UNITED STATES PATENT AND TRADEMARK OFFICE

Office Action Summary	Application No. 10/518,532	Applicant(s) BORGOLTZ ET AL.	
	Examiner M. Alexandra Elve	Art Unit 3742

DETAILED ACTION

Fig.14.

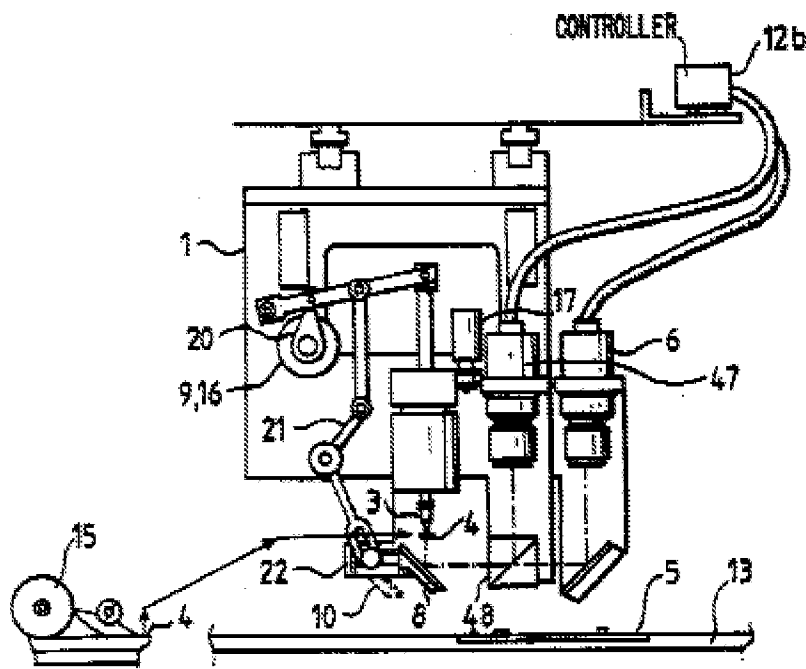
Applicant argues that the prior art does not teach "the first wide field camera, the second narrow field camera, and the laser source disposed to use partly a same optical path". The examiner respectfully disagrees because Tomita et al. discloses the use of the same path from 4/8 to both 6 & 47; see below:
